Regarding: 10V-365

SAFETY RECALL

2006 ~ 2010 YZF-R6 MODELS

FACTORY MODIFICATION CAMPAIGN – Front Side Reflectors

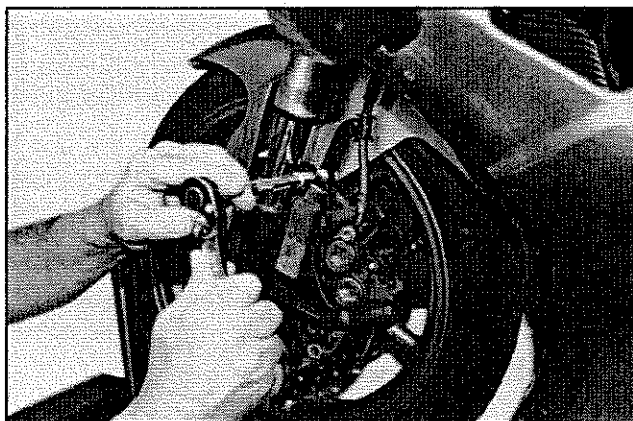
1. Remove the original front reflectors and brackets (RH & LH) by removing the 6mm Allen bolt and nut.

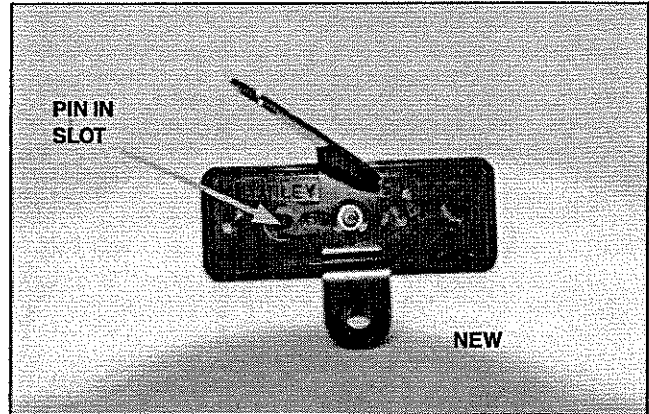
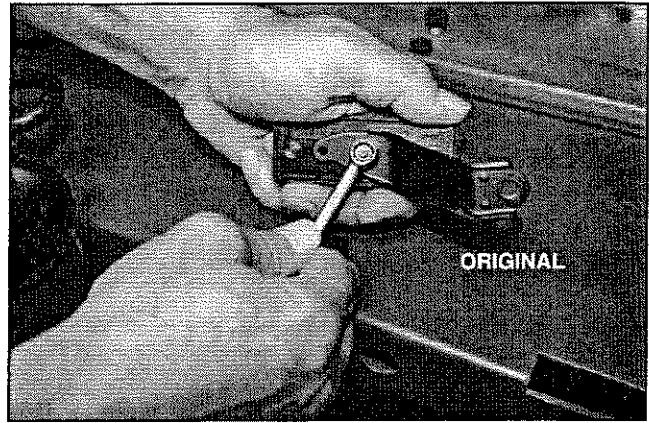
2. Remove the reflectors from the original brackets and install them on the new brackets, aligning the pin on the reflector with the corresponding slot in the new bracket.

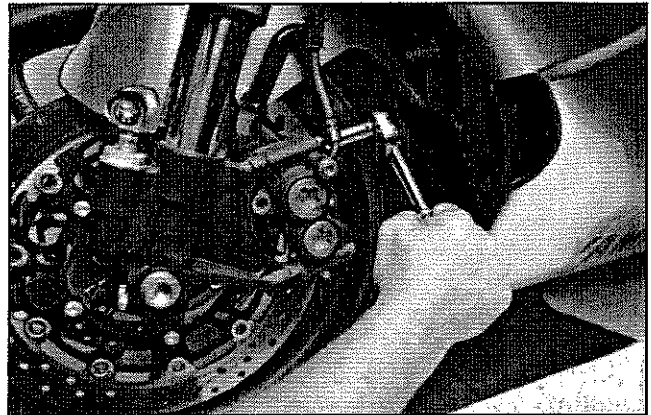
3. Remove the upper brake caliper mounting bolts.

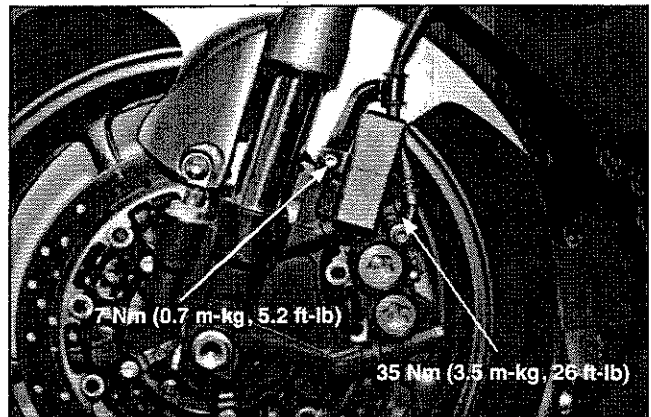
4. Install the new reflector brackets (RH & LH side) with the reflector installed, using the original mounting point and the new upper brake caliper mounting point. Torque the mounting bolts to specification

IDENTIFICATION PROCEDURE

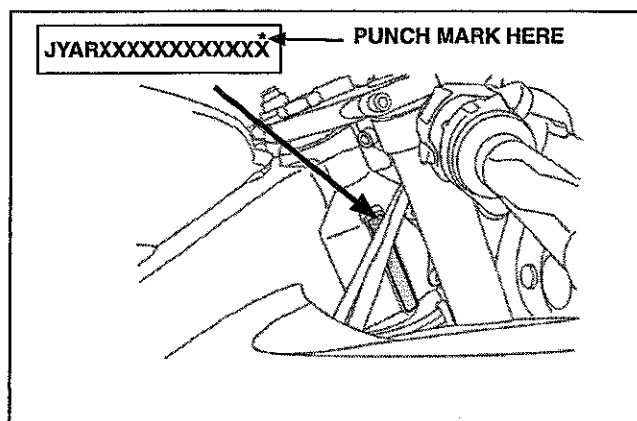
When the modification is complete, put a punch mark above the last number of the VIN as shown. Check for this punch mark if you encounter an unfamiliar unit. You can also check unit status on YDS or by contacting your Regional Technical Advisor.
